Response to plans for Cheetham Hill cycleway and Wilmslow Road cycleway 2nd January 2015

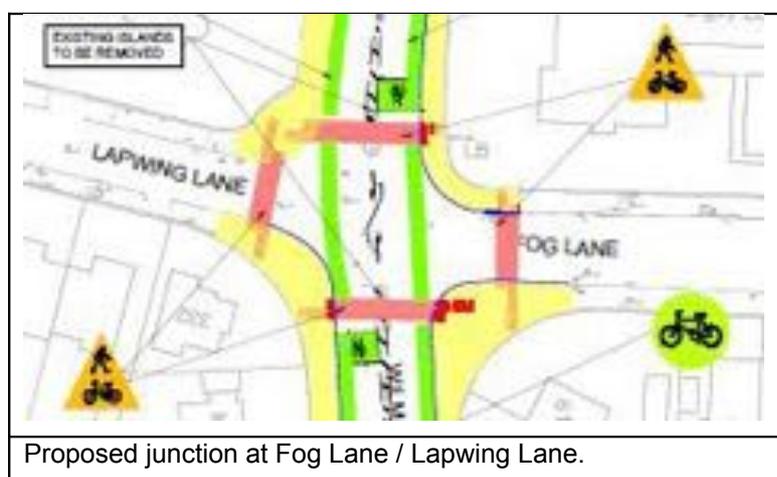
Shortly after the bus bypass section of the northbound route the Outline Design (Drawing number 208235/1.1-1/0000/0002) indicated that the 2 metre cycle route is reduced to 1.5 metres for a short section (approx 20 metres).

It is unclear from the later version on the consultation website (Drawing number 208235/E1/COM/002) whether this width reduction is still planned. It is also unclear from visiting the site why this was proposed.

Drawing number 208235/E1/COM/005

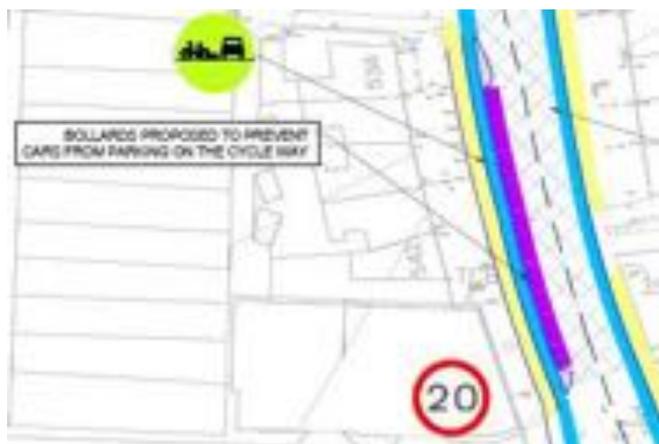
It is not clear from Drawing number 208235/E1/COM/005 how the route that crosses the junction with Cotton Lane (southbound) will be a “segregated cycle lane / cycle lane on footway” (blue lane) as it crosses the Cotton Lane carriageway. See diagram below.

The Cycle Route Audit Tool safety category includes the factor “Avoid high motor traffic volumes where cyclists are sharing the carriageway”. This is based on the design principle that “Cyclists should not be required to share the carriageway with high volumes of motor vehicles. This is particularly important at points where risk of collision is greater, such as at junctions”.

The Red category (a score of zero) is defined as 500-1000 vehicles per peak hour and between 2-5% HGV traffic. The traffic volume for this section of Wilmslow Road is 537 (All motors) southbound in the PM peak and 544 (All motors) northbound in the AM peak which would score zero on the Cycle Route Audit Tool.²⁴

Existing bus stop layout

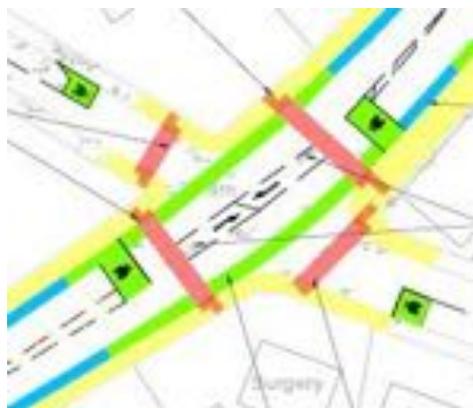
The diagram (Drawing number 208235/E3/COM/001) indicates that by Withington Library the route would direct people to cycle between the ‘stopped’ buses and motorised traffic. Green cycle icons would designate the cycle route. See diagram below.

The reasons given were that there is insufficient space to the north end of the bus layby to provide an adequate bus-stop bypass route.

However, one option would be to alter the Wellington Road / Wilmslow Road junction. Moving the junction neck several metres to the south would provide additional pavement space outside the library entrance and allow the bus layby to be moved to make space for a bus-stop bypass.
